Re: Rapiscan AIT System Radiation Survey Reporting

Rapiscan SYSTEMS	Secure 1000 Radiation Emission Measurement	FORM R-0646-1 (Single Pose)
----------------------------	---	--------------------------------

R-0646-1 Addendum (Documentation Errors)

1. In Beam Dose Measurement: Survey Table. 1

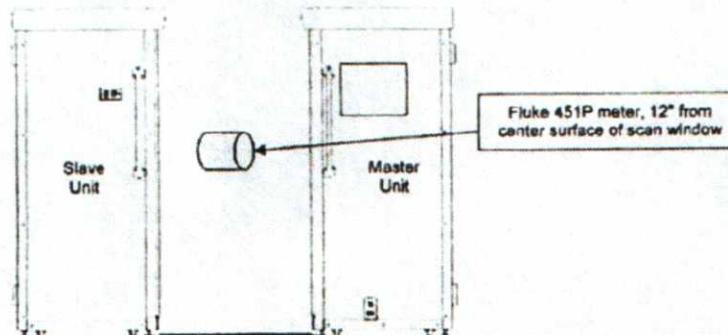
1. TABLE 1: Incorrect presentation of data in Column 3 for Measured Exposure. Indicated values are 17uR and 16uR. Corrected values are 1.7uR and 1.6uR
2. TABLE 1: Incorrect presentation of data in Column 6 for Effective Dose. Indicated values are 9.8 uRem and 9.8 uRem. Corrected values, per RSO corrections, are .977 uRem and .92 uRem.
3. Technician incorrectly marked the fail check box.

The service technician should attend refresher training.

The corrected data indicates this system was operating within expected parameters. No re-survey is required for this system.
